Thank you for the opportunity to respond to the “RIIO-T1: Consultation on draft decision on National Grid Gas Transmission’s application under the RIIO-T1 Compressor Emissions uncertainty mechanism”. Our interpretation of Ofgem’s minded to position is in essence to delay making a decision until the 2018 reopener window. In this response by National Grid Gas Transmission (NGGT) we raise our concerns about this approach and provide further evidence to respond to the key points raised by the consultants.

Appendix 1 – CBA Hatton need case

Appendix 2: RB211 DLE Retrofit Emissions Assessment

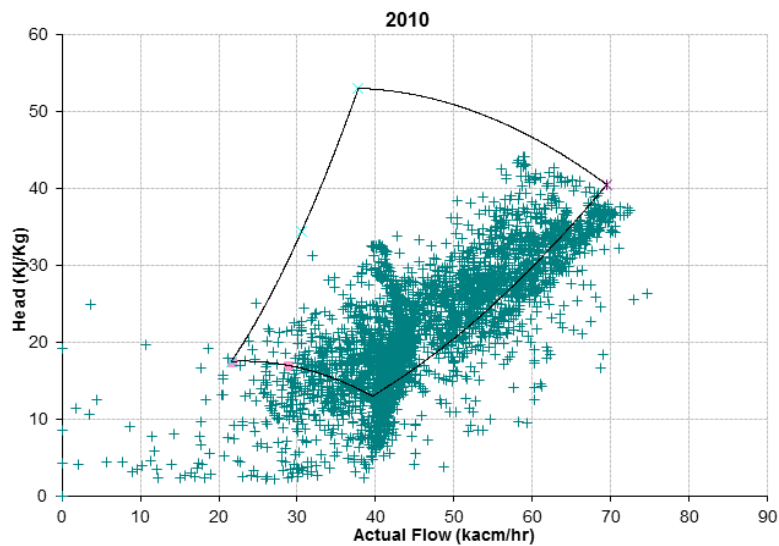
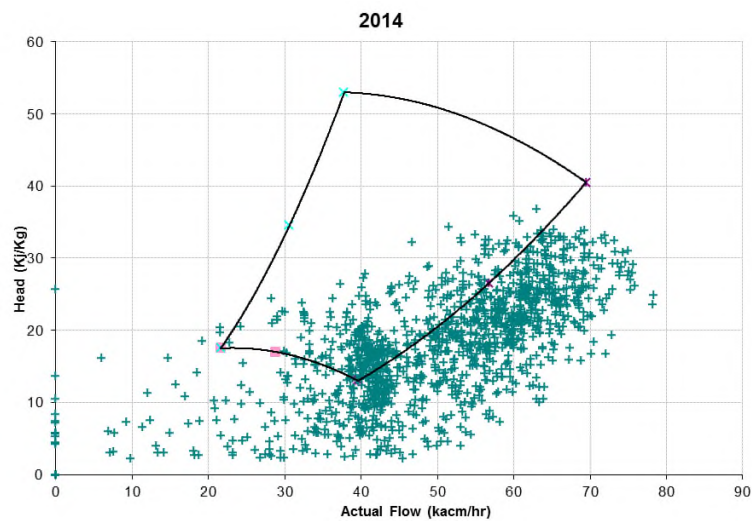
In addition to the constraint analysis, below we show the recent operational data (pressure and flow) with the Unit D operating envelope overlaid. The data shows the points at which the compressor has been required to operate at based on supply and demand patterns in 2010 (a relatively cold winter) and 2014 (a relatively mild winter). Any point outside of the enclosed envelope would need to be covered by another unit.

Based on the required duty, there would have been circa 600 and 1075 hours of operation that could not have been met at Hatton without additional compression in 2010 and 2014 respectively. The analysis excludes operating points associated with compressor start up. Given the combination of the normal operating duty being well in excess of 500 hours and the potential constraint costs, we conclude that the cost / benefit of installing one new unit is robust.

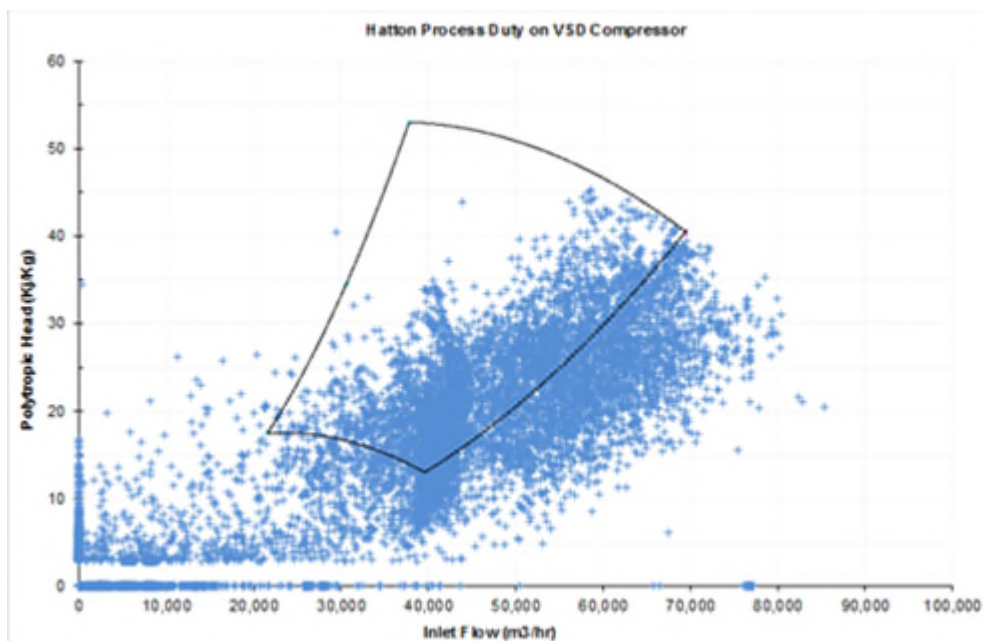
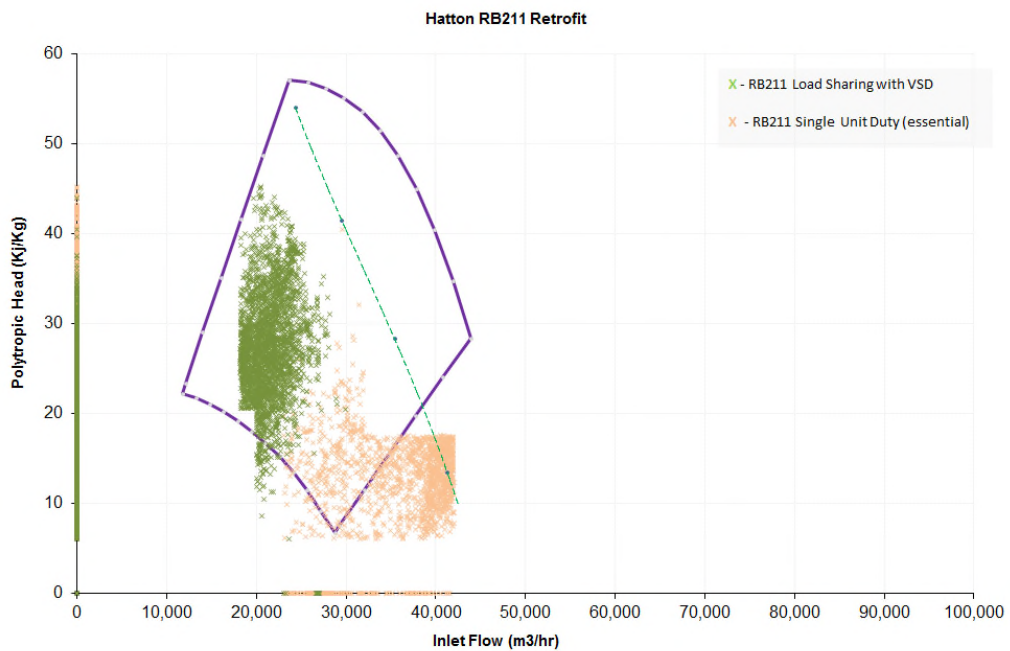
In terms of performance, the new retrofit RB211 DLE would need to operate in conjunction with Unit D, which is a 35 MW electric driven compressor. In Appendix 2, we show the typical duty points at Hatton and the points that would need to be covered by the RB211 DLE retrofit in either single or parallel operation with the larger unit D. The vast majority of the data points are below 70% load.

Below 70% the RB211 DLE retrofit is not able to meet the CO emission levels as specified in the IED. It would therefore not represent a BAT solution.

However, the RB211 DLE retrofit is only compliant with the CO emission limit specified in the IED at above 70% load and the diagram below shows the 70% load line. It can be seen that the vast majority of the data points fall outside of this range and therefore the RB211 retrofit is not considered BAT for Hatton.
